Re: The 24's @ Uptown
2424 Louisiana Blvd NE
Traffic Circulation Layout
Architect's Stamp 05-23-17 (H19D001)

Based upon the information provided in your submittal received 06-01-17, the above referenced plan cannot be approved for Building Permit until the following comments are addressed:

TCL

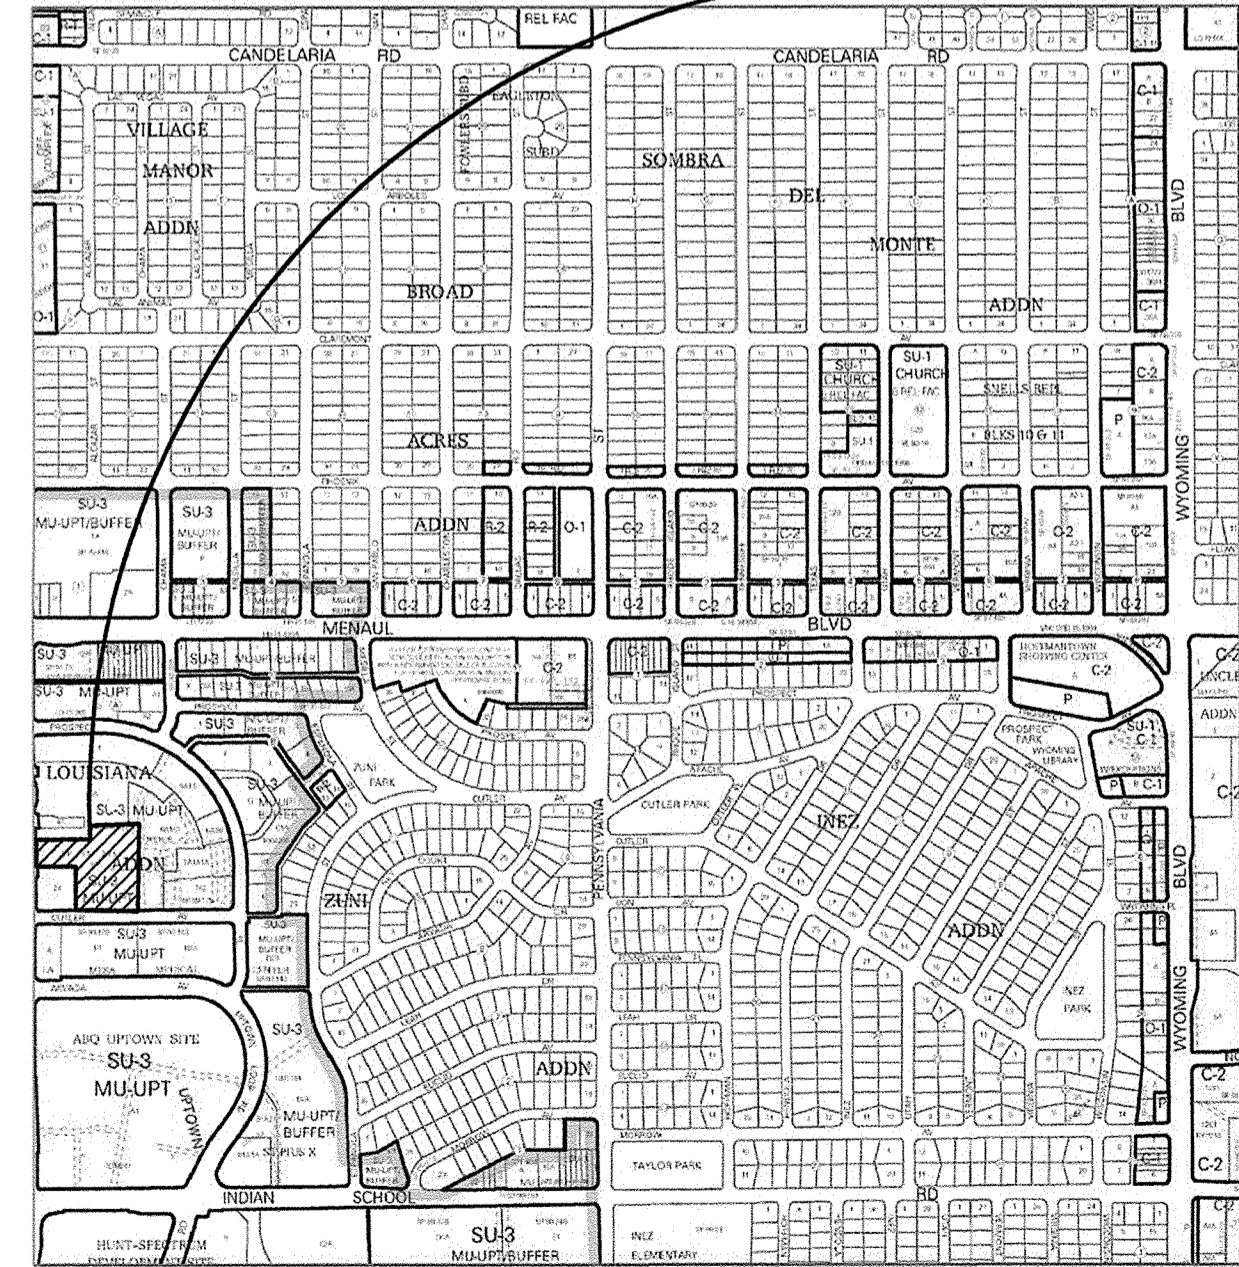
1. The proposed parking spaces located at the east entrance of the parking garage must be removed.
2. The handicap accessible spaces must be a minimum of 8.5 ft. in width.

3. The handicap accessible spaces must include an access aisle. Van accessible aisles should be 8ft wide; all others should be 5ft wide.
4. The ADA accessible parking sign must have the required language per 66-7-352.4C NMSA 1978 **"Violators Are Subject to a Fine and/or Towing."** Please call out detail and location of HC signs.

5. The ADA access aisles shall have the words **"NO PARKING"** in capital letters, each of which shall be at least one foot high and at least two inches wide, placed at the rear of the parking space so as to be close to where an adjacent vehicle's rear tire would be placed. (66-1-4.1.B NMSA 1978)

6. Per DPM, a 6 ft. wide ADA accessible pedestrian pathway is required from the HC parking stall access aisles to the building entrances. Please dimension all ADA access aisles.

7. A ramp with a 5' radius located behind the ramp must be provided at the above ground ADA access aisle.
8. One-way vehicular paths require pavement directional signage and a posted **"Do Not Enter"** sign at the point of egress. Please show detail and location of posted signs for all one way paths.

9. Provide dimensions and radii for the one way entrance to the new above ground parking area.
10. Signage for above and underground parking must be provided.

11. Please provide a note and details regarding the access control to the underground parking.

FLOOR PLAN

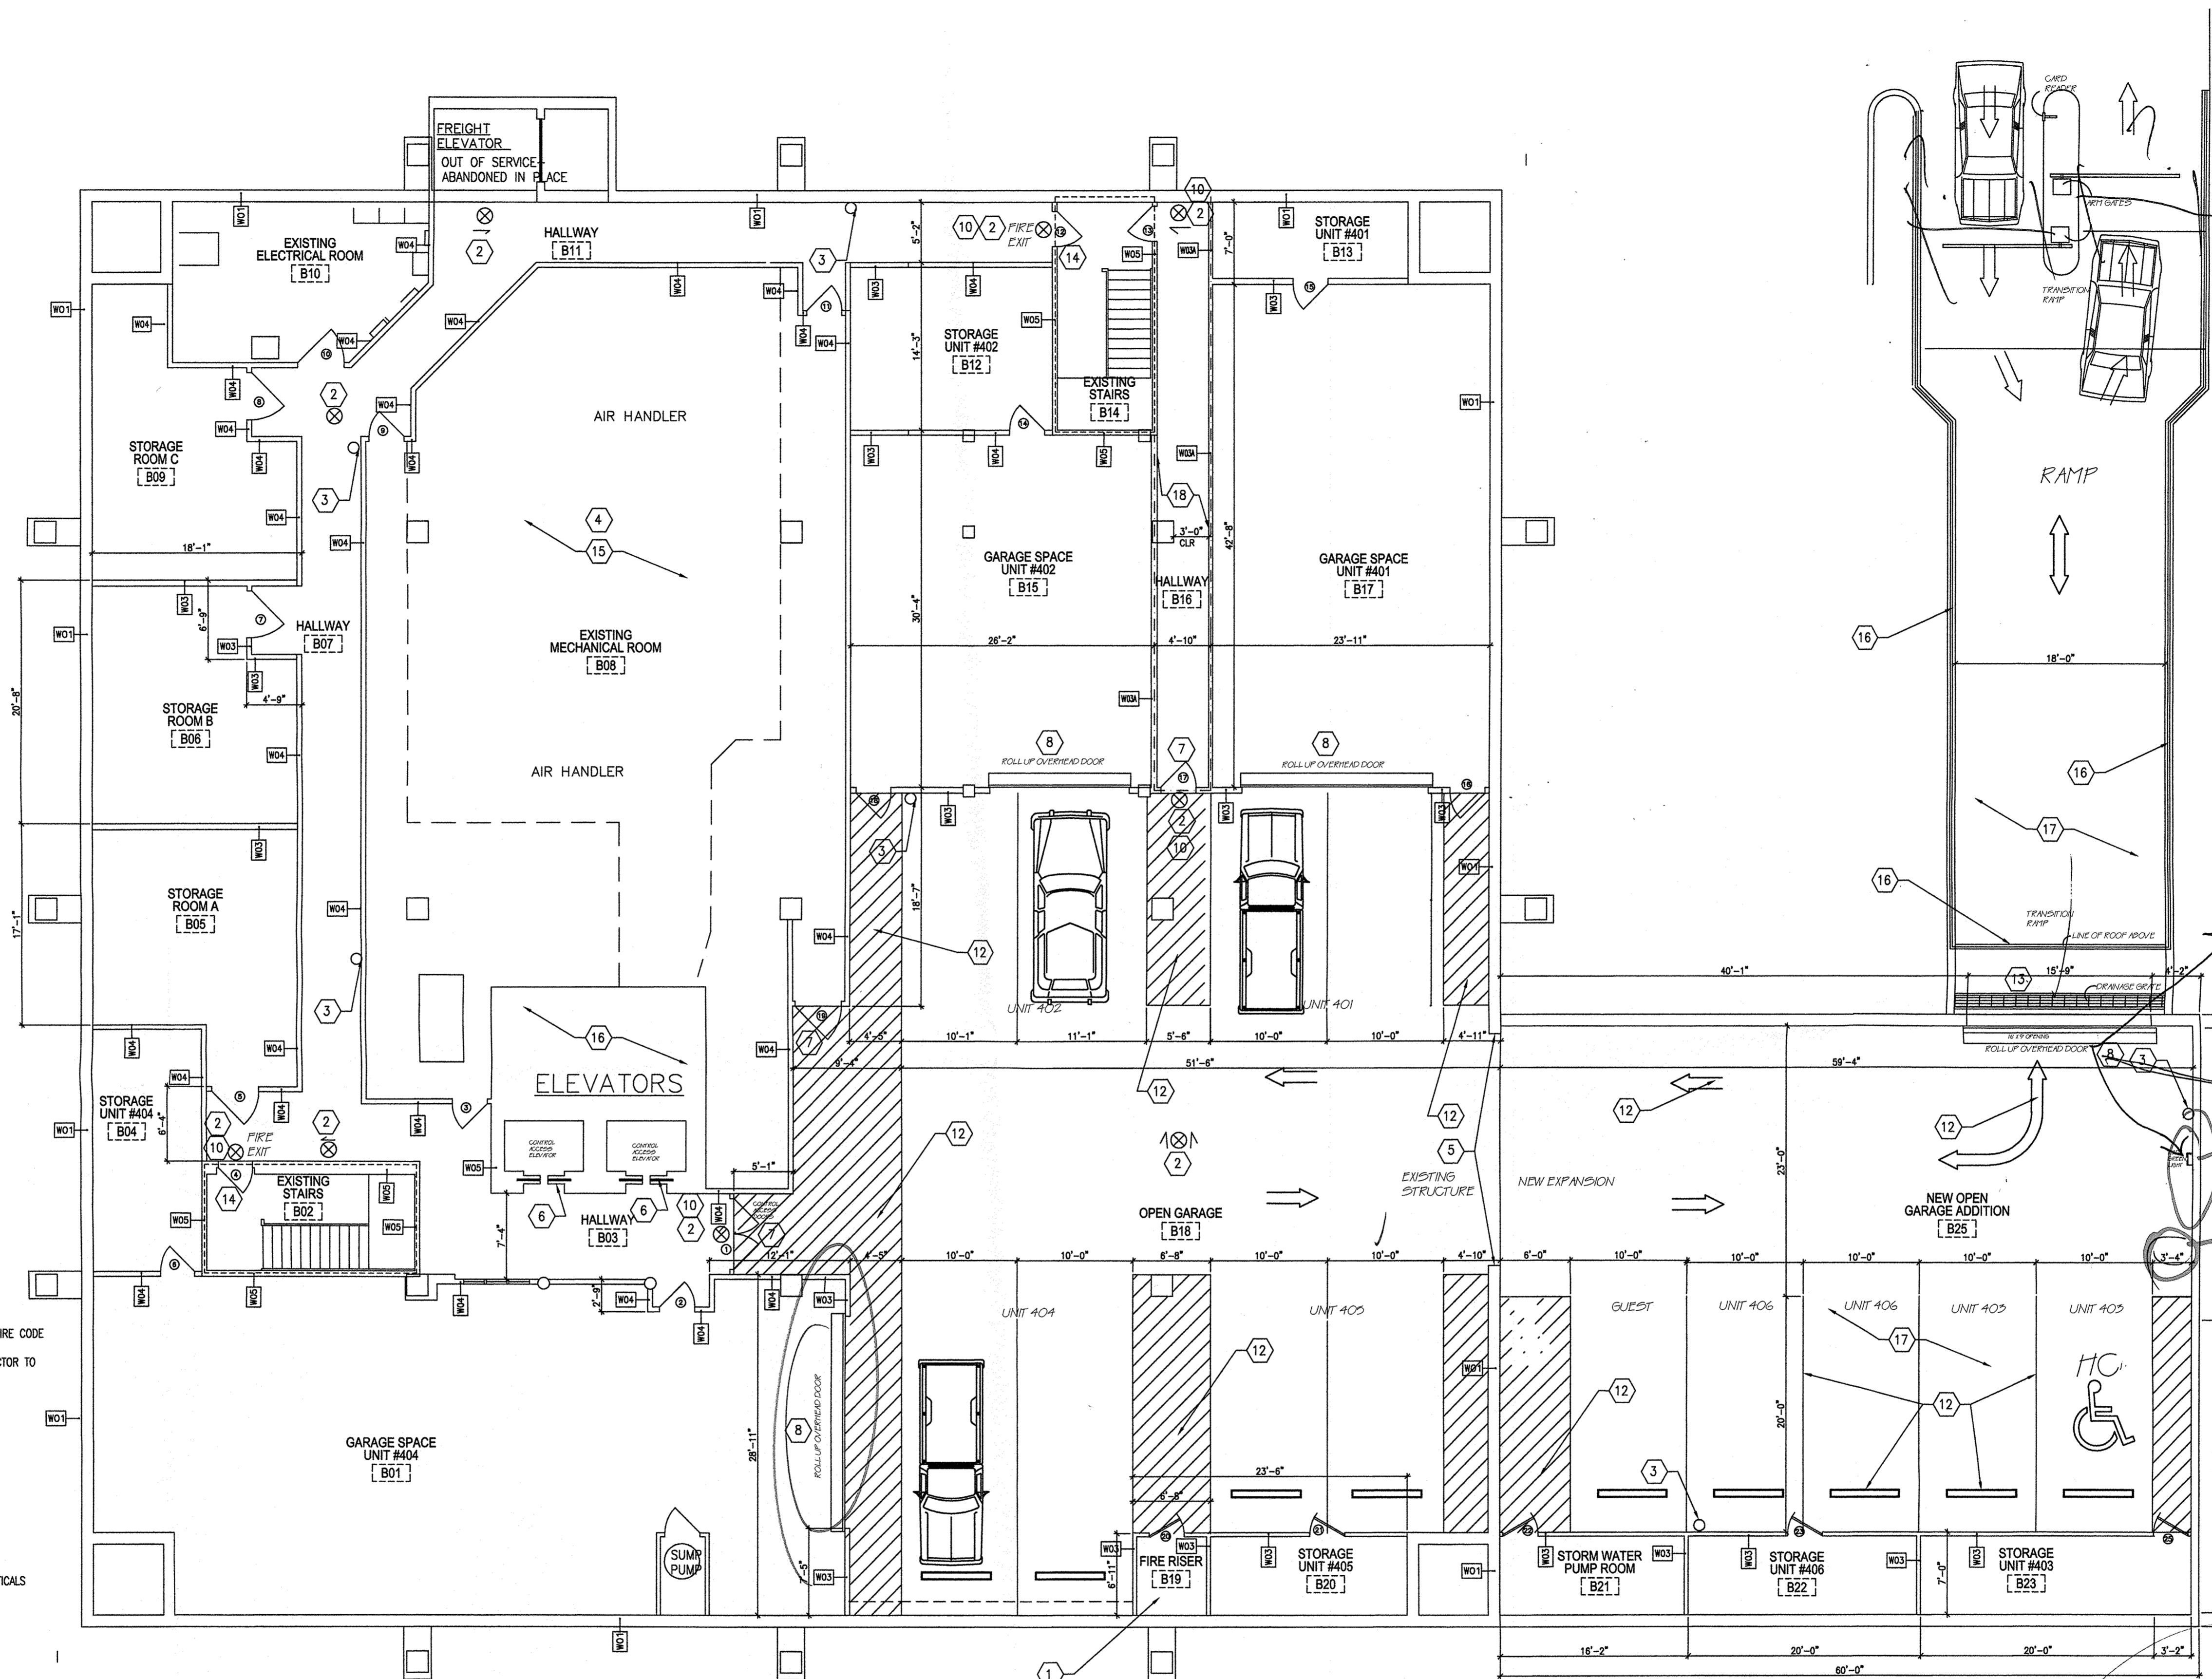
Light will notify driver as to exit or enter when 18" drive is clear

Turnkey is clear

Not wide enough for van etc

Std H.C 13'-11"

Parking given only vehicle by hand on 4th floor only each space has its
